**ADDENDUM NO 1
TO
CONTRACT DOCUMENTS
FOR
DEEP WELL # 7 UNDERGROUND WELL IMPROVEMENTS
Page 1 of 10**

**DISTRICT PROJECT NO. 4312
10/21/2022**

WELL SITE OVERVIEW

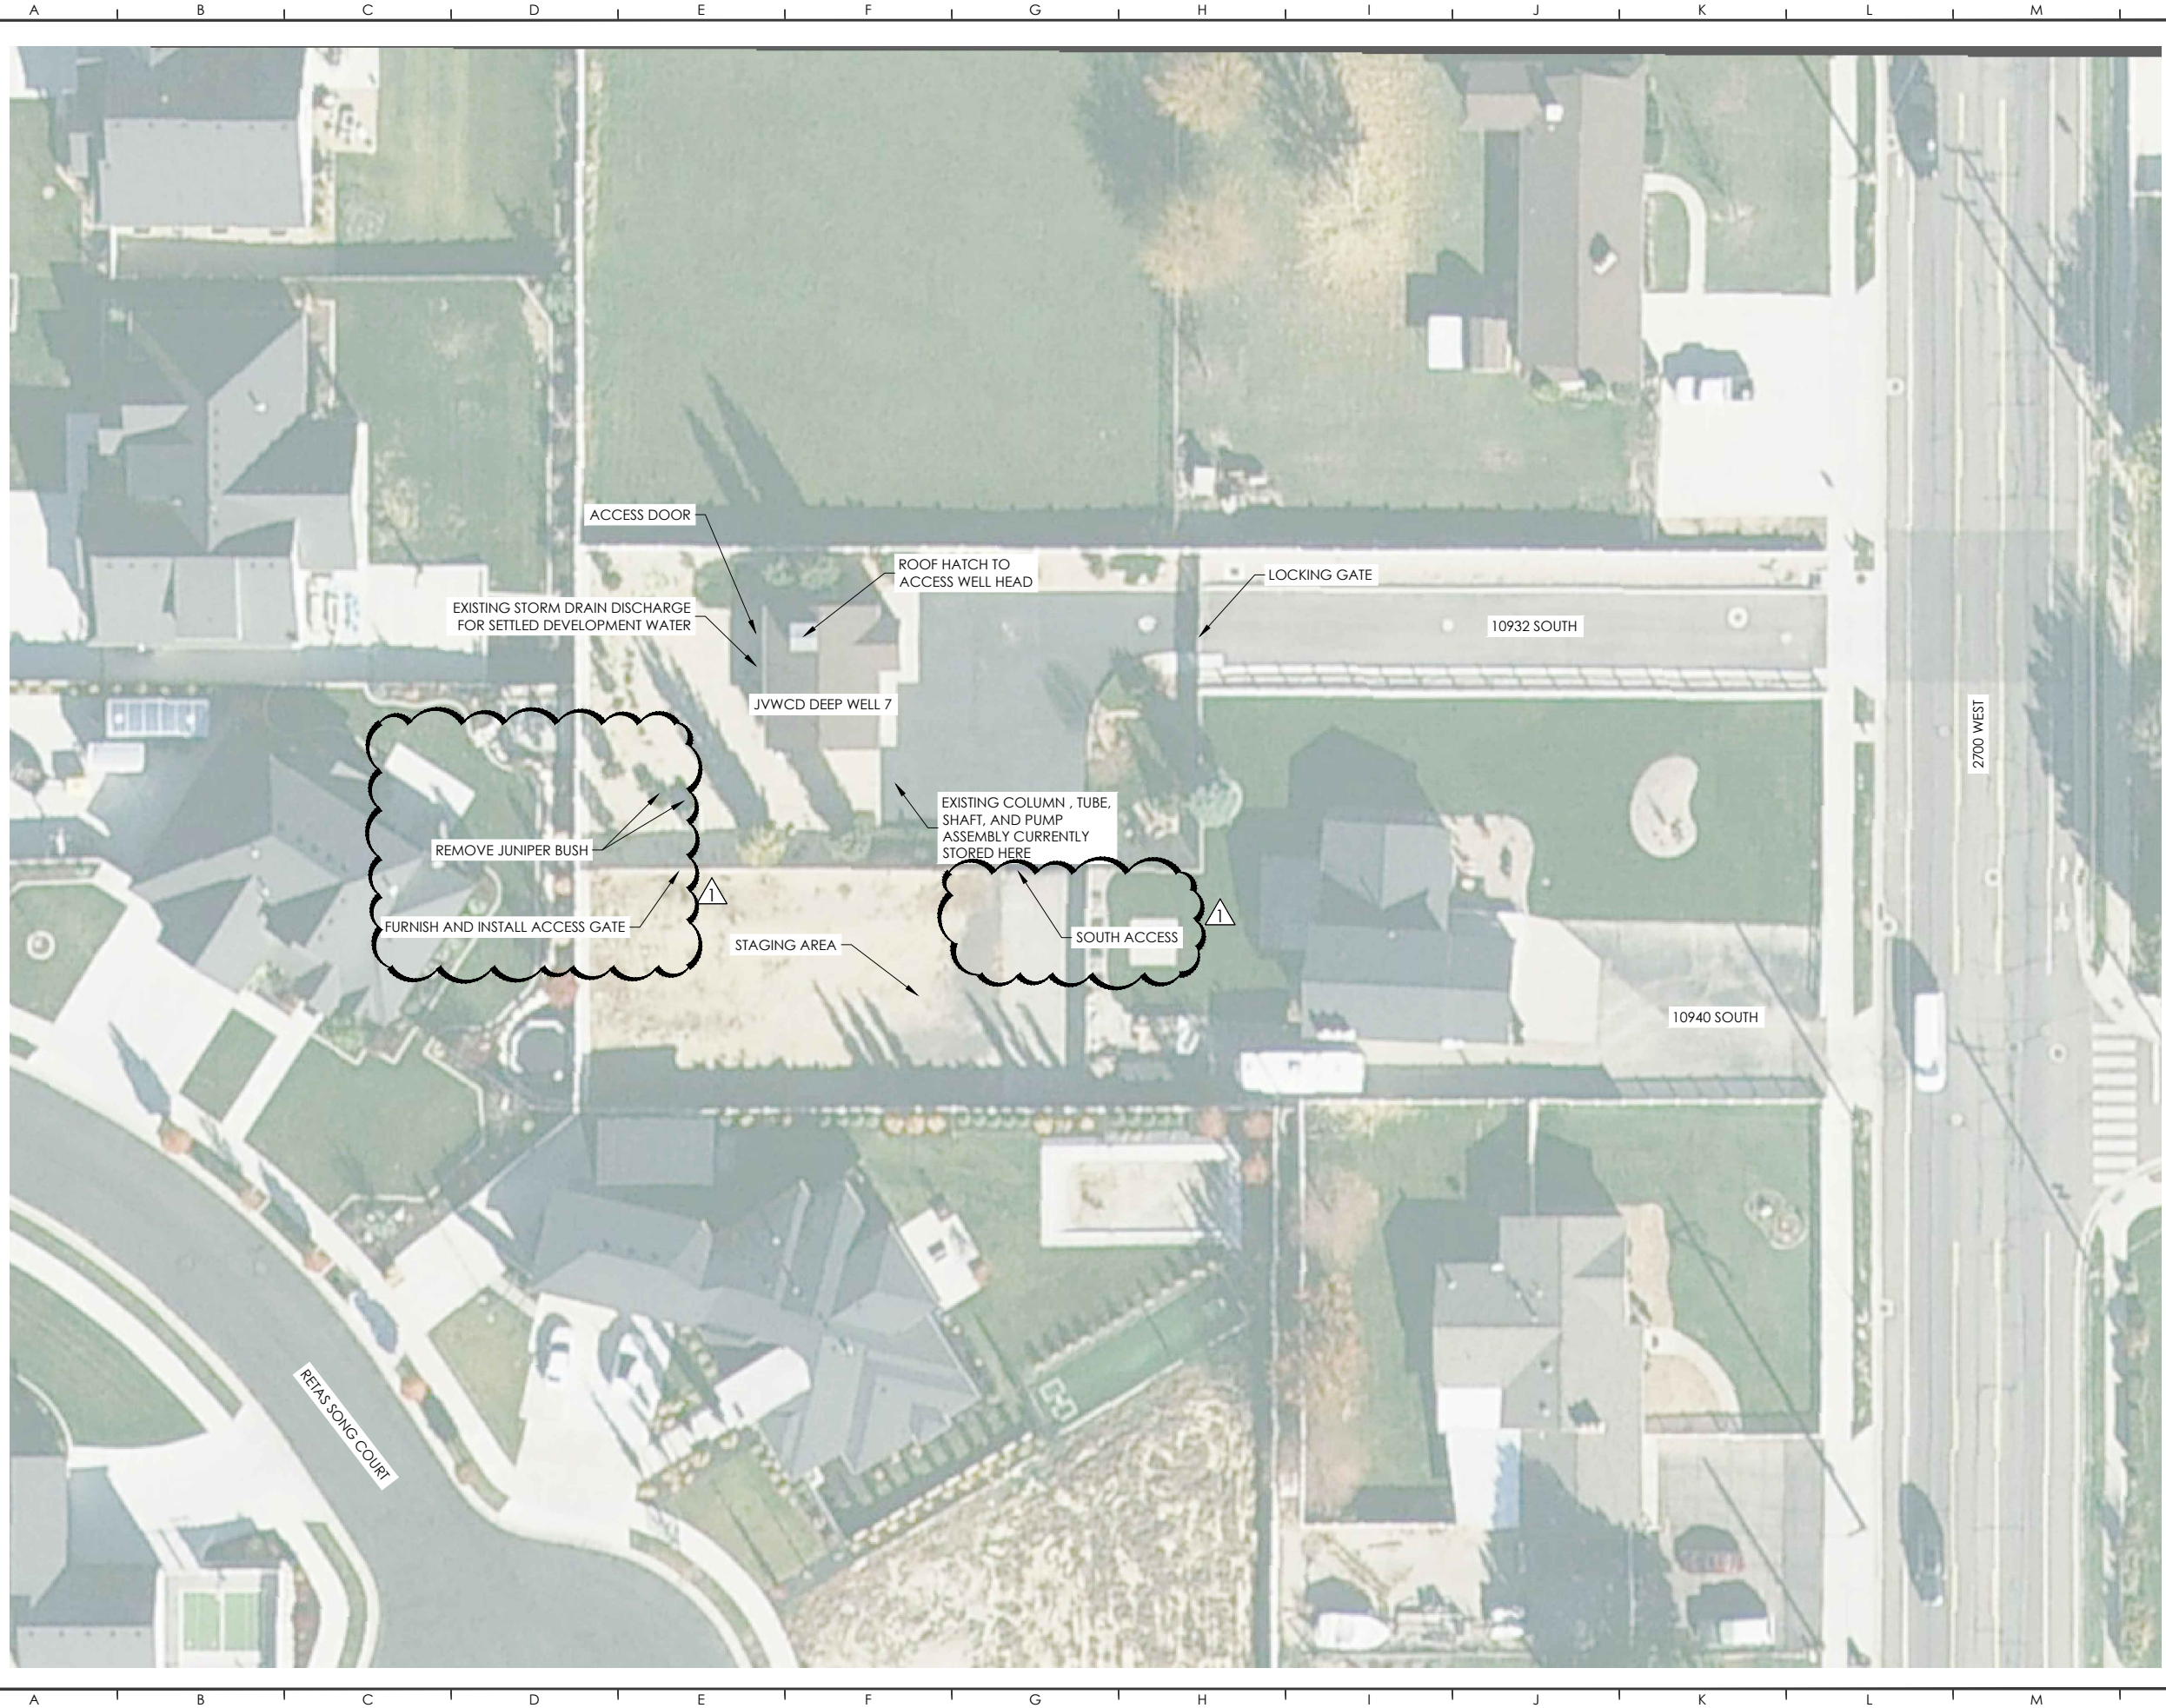
4. Optional bid item- Chain Link drive gate-JVWCD owns the staging area immediately to the south of the DW7 site. Contractor at their option may access the west side of the pump building by cutting the existing vinyl coated chain link fence (with slats). If exercised, the contractor shall furnish a 12-ft (minimum) wide drive gate (matching existing fence with option to reuse fence fabric) at the access point. Two juniper bushes may be removed and not replaced (cap drip irrigation). The bid schedule has been updated to show this as a bid item. The bid item will be paid if the contractor completes this work for the future benefit of the District.

13. Furnish and Install 12-Foot Chain-link Double Swing Gate – Measurement and Payment shall be made by the lump sum and lump sum price shown on the bid schedule. Payment covers:

- a. **Furnishing and installing a 12-foot chain-link double swing gate at the south access to the site**

3 DW 7 WELLHEAD CONFIGURATION
SCALE: NONE

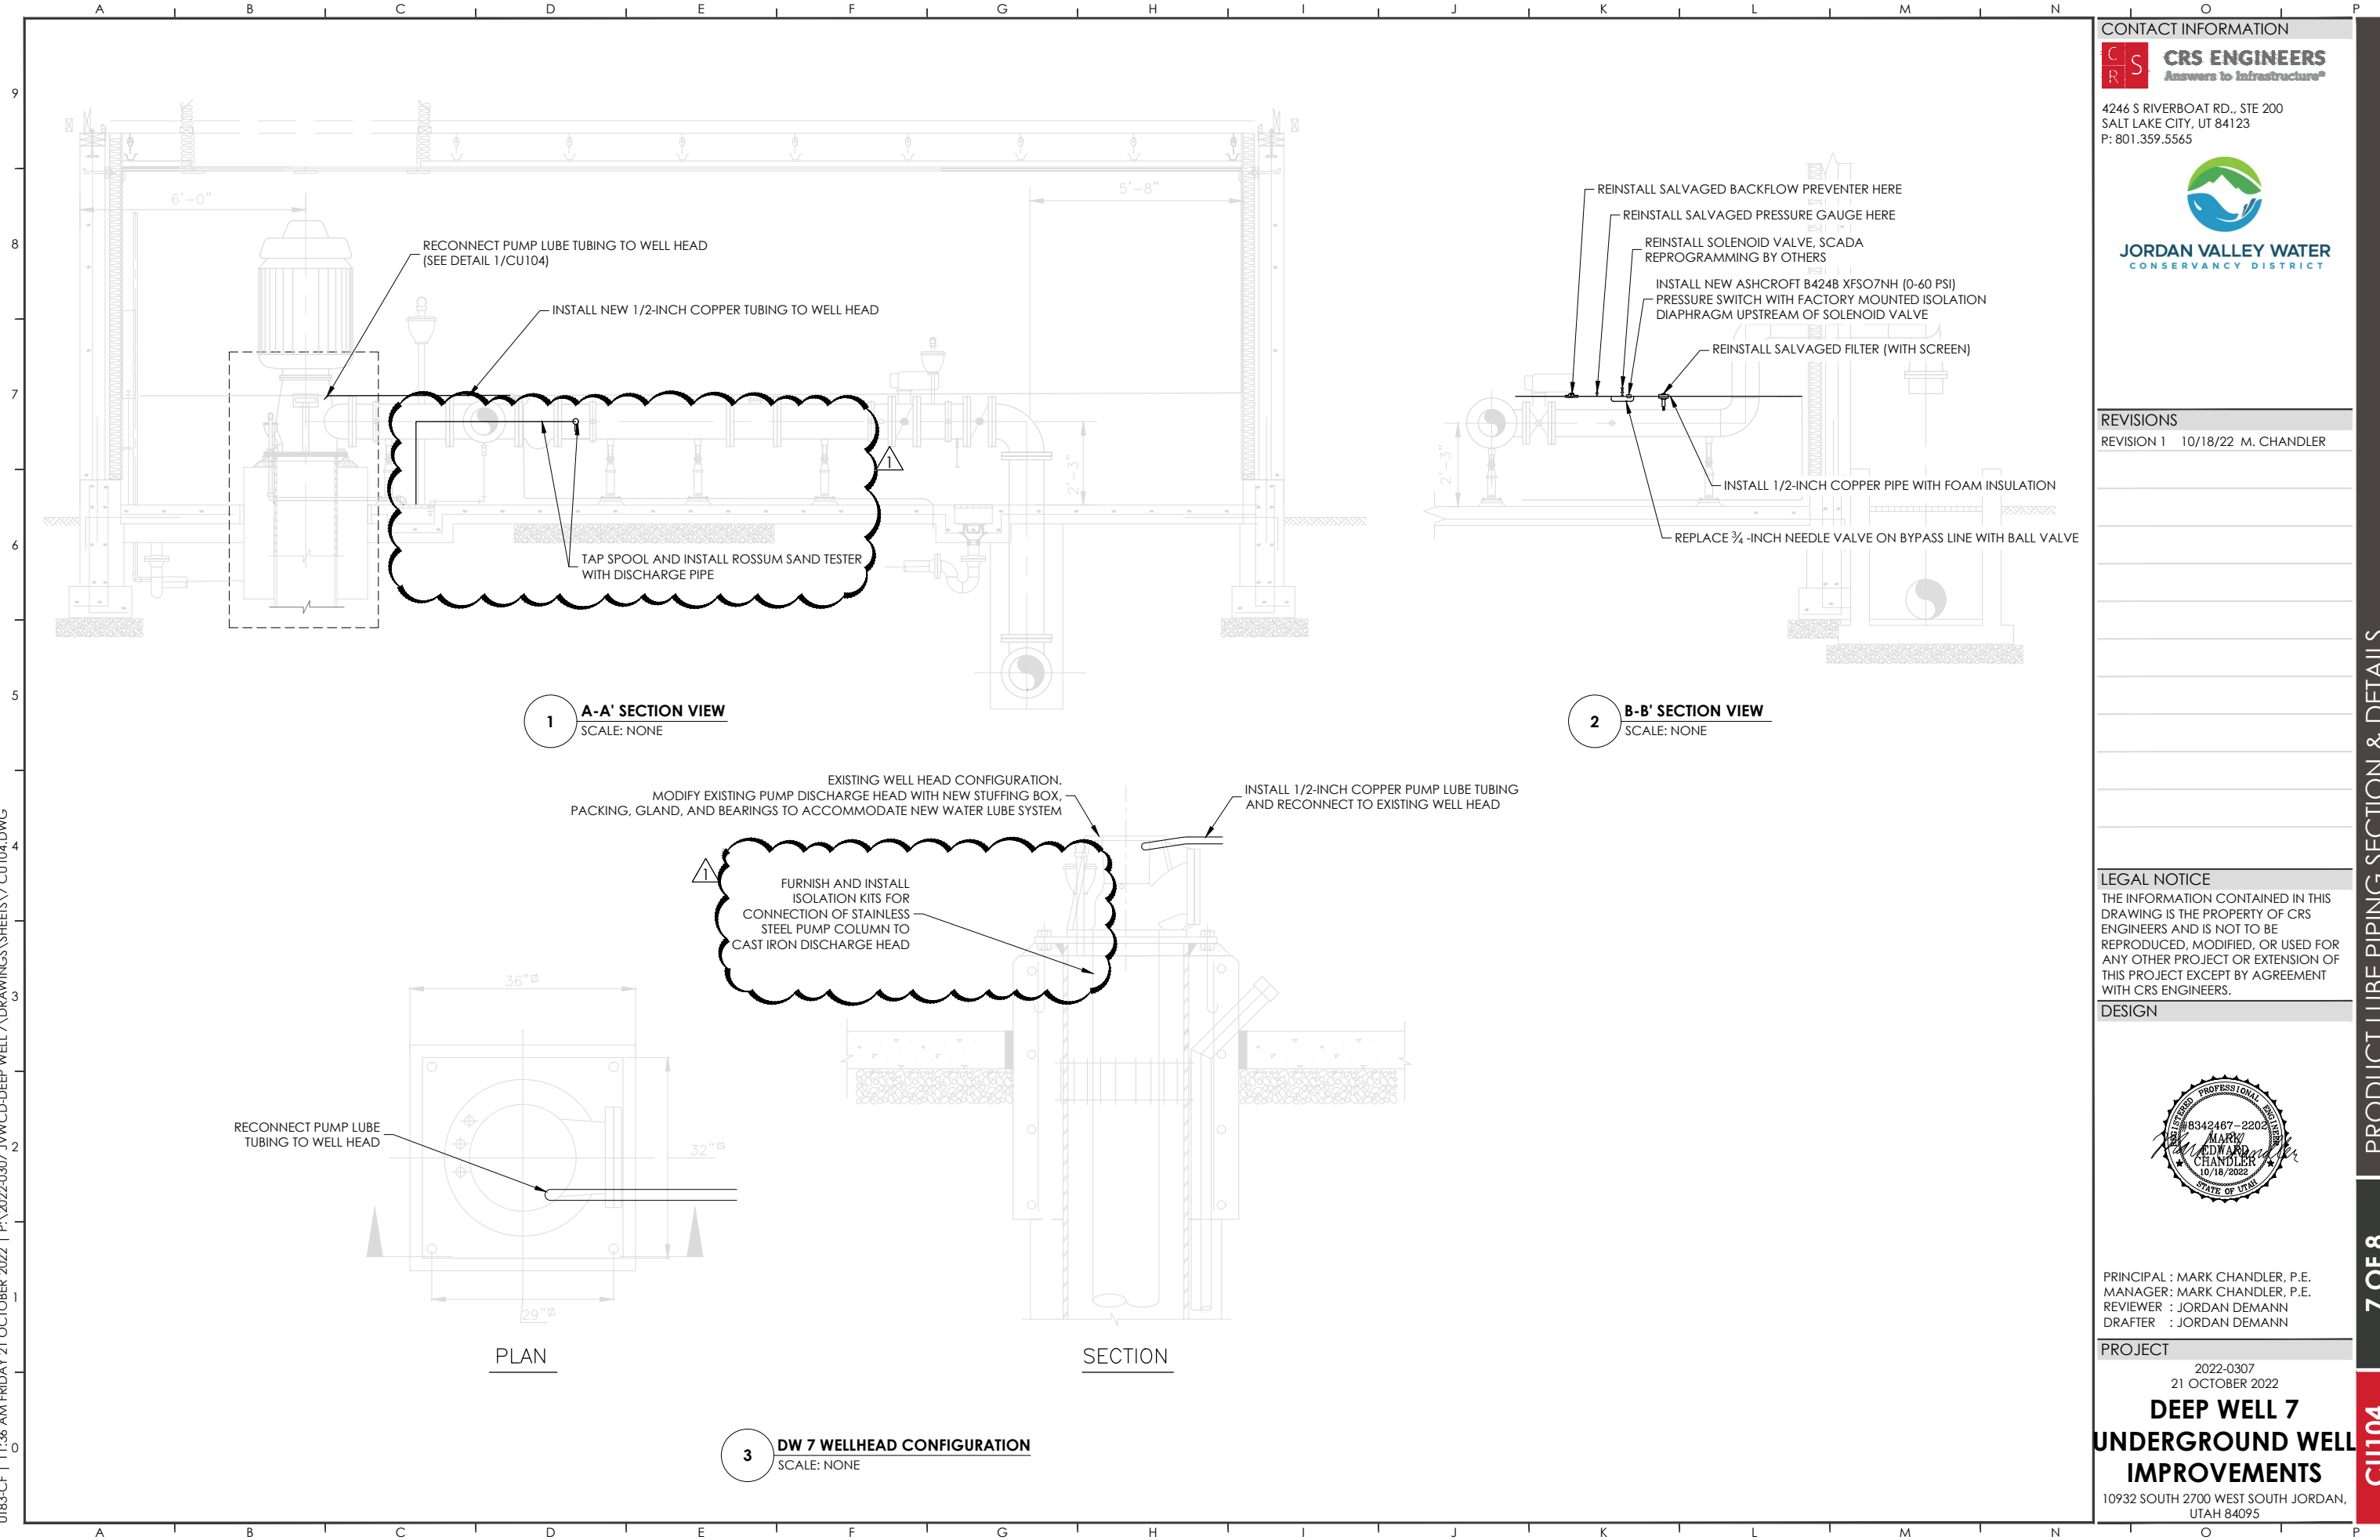
2. Contractor shall furnish and install one isolation kit for the connection of the stainless-steel pump column and the cast iron discharge head.
3. Contractor shall furnish and install one Rossum manufactured sand tester at an existing well discharge access point as directed by engineer (<http://www.rossumsandtester.com/>).

- i. Replace continuity wire and connect to existing test head.
11. **Furnish and Install Isolation Kits – Measurement and Payment shall be made by lump sum and lump sum price shown on the bid schedule. Payment covers:**

- a. **Furnishing and installing isolation kits for the connection of the stainless-steel pump column to the cast iron discharge head.**
 - b. **Payment shall be made for the actual cost of isolation kits purchased and installed**
